APPLICATION NO.	FILING DATE	FIRST NAMED INVENTOR	ATTORNEY DOCKET NO.	CONFIRMATION NO.
10/653,249	09/03/2003	Harumichi Oishi	Q77285	2780
23373	7590	12/27/2005		
SUGHRUE MION, PLLC 2100 PENNSYLVANIA AVENUE, N.W. SUITE 800 WASHINGTON, DC 20037			EXAMINER LANGDON, EVAN H	
			ART UNIT	PAPER NUMBER
			3654

Office Action Summary	Application No. 10/653,249	Applicant(s) OISHI ET AL.	
	Examiner Evan H. Langdon	Art Unit 3654

DETAILED ACTION

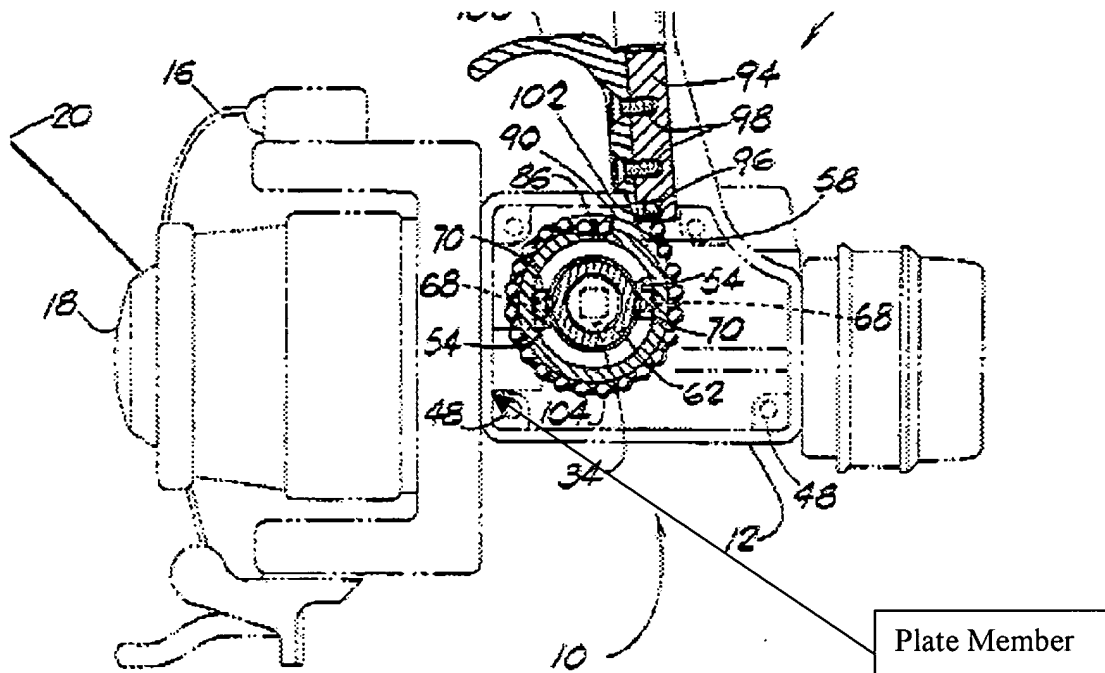
a handle 30 disposed at a side portion of the reel body for rotating the spool to winding a fishing line on the spool; and

an auxiliary operating member 10, 100 for auxiliary winding the fishing line on the spool provided at a position in which the auxiliary operating member can be operated by a finger of an angler's hand holding the fishing rod to which the reel body is attached, wherein the auxiliary operating member is formed so that, when the handle is rotated to rotate the spool, the auxiliary operating member is not rotated in response to the rotation of the handle (col. 5 lines 29-44),

wherein a one-way clutch 62, 70, 52 is interposed between a rotating member 34 where the rotating member is rotated in response to the rotation of the handle 30 and the auxiliary operating member 10, 100,

wherein an operating portion of the auxiliary operating member to be operated by the finger is rotatably provided between left and right side plates which constitute the reel body, and wherein the operating portion is formed in a lever shape 100, and

a plate connected between the left and right side plates to partially form an upper surface of the reel body, wherein the plate is respectively positioned between the operating member and a front-end of the reel body, and wherein the operating portion is projected upward from a surface of the plate (see below).
